CASE OFFICER'S REPORT

Application Reference: PL/2023/09847 and PL/2023/10353
Application Address: 93 Priory Lodge, Brown Street, Salisbury, SP1 2BX

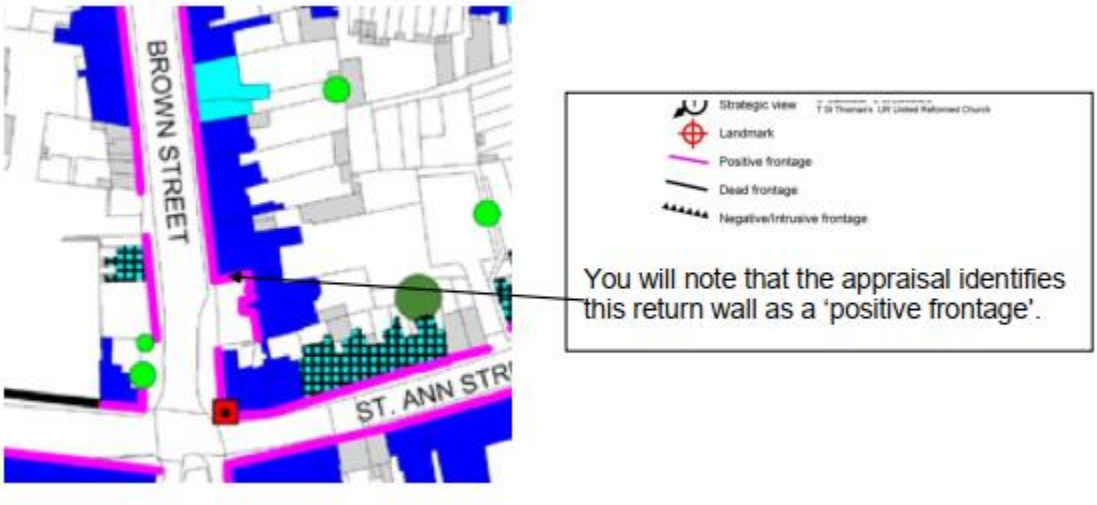
The application refers to intended repointing works on various parts of the building and includes a photo of its south elevation before work started. This wall has now had a great deal of repointing work done to it, prior to submission of the application, and its appearance has radically changed, to one which is not appropriate for the listed building. The mortar colour is far too white, and it has been applied in a way which unnecessarily increased the amount of it which is visible.

The pre-application advice, quoted on the application form, refers to the 2007 repointing of the front of the listed 5 St Ann Street, very close by, and says it has a more acceptable appearance. While the two cases are not precisely comparable, given that the bricks at Priory Lodge are clearly in less good condition than those at 5 St Ann Street, the Priory Lodge repointing could certainly have been carried out with more attention paid to slightly exposing the arises of the bricks, where these retain some shape, and to preventing the straying of mortar onto the faces of the bricks.

The mortar at 5 St Ann Street was a carefully gauged mix of Wareham Washed sand and yellow builder's sand, and the resultant colour is far less strident than that used on Priory Lodge, and much more in keeping with the character of a historic building. Combined with a more judicious approach to application of the mortar, the overall effect is one where the bricks predominate, rather than the mortar.

It seems unlikely that scraping back of the mortar at Priory Lodge, and the application of some toning down technique, would actually restore the wall to an appropriate appearance, and raking out of the mortar and starting again is likely to be the approach that would actually succeed.

Given the unfortunate appearance that the southern wall has taken on, it is clearly essential that any other repointing work, yet to be carried out, is approached in a different way.
